Re: Rapiscan AIT System Radiation Survey Reporting

**R-0646-1 Addendum
(Documentation Errors)**

Product Name	Secure 1000SP (Single Pose)
Serial Number	S50951001
Radiation Emission Measurement	Radiation Survey Dated: 01/26/2010
RSO Initials

1. In Beam Dose Measurement: Survey Table. 1

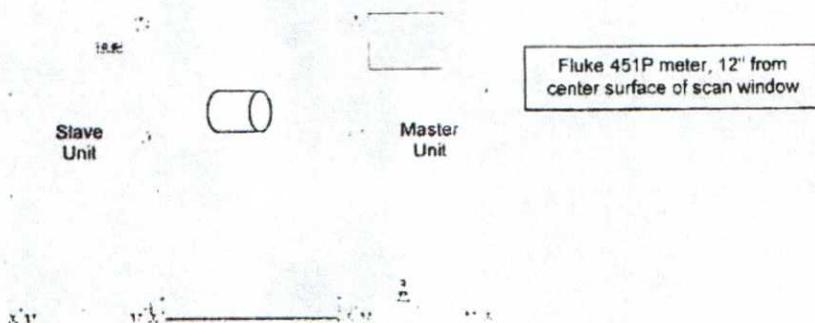
1. Technician indicated scan time as 7 seconds. Correct scan time is 3 seconds.

The service technician should attend refresher training.

The corrected data indicates this system was operating within expected parameters. No re-survey is required for this system.
